AIRGAIN[®] SKYWIRE[®]
NL-SW-LTE-TC4NAG
NL-SW-LTE-TC4NAG-B

Product Change Notification - End of Life (EOL)

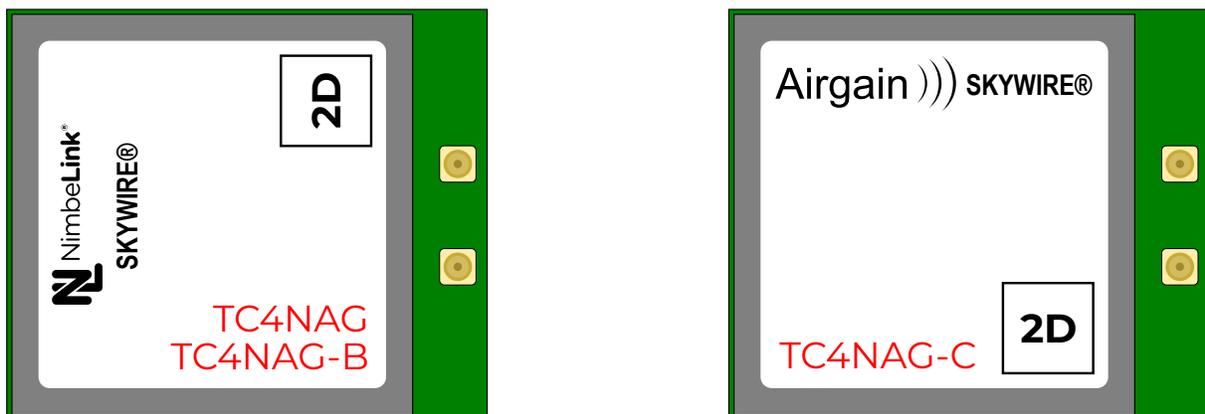
The NL-SW-LTE-TC4NAG and NL-SW-LTE-TC4NAG-B are being transitioned to EOL because their underlying Telit Cinterion modules have reached the end of their PTCRB 3-year NAPRD03 validity periods. This has the following implications for end products:

- End products obtaining initial PTCRB certifications must use the NL-SW-LTE-TC4NAG-C.
- End products with existing PTCRB certifications may continue using NL-SW-LTE-TC4NAG and NL-SW-LTE-TC4NAG-B modems. However, Airgain advises adopting the NL-SW-LTE-TC4NAG-C as soon as possible.
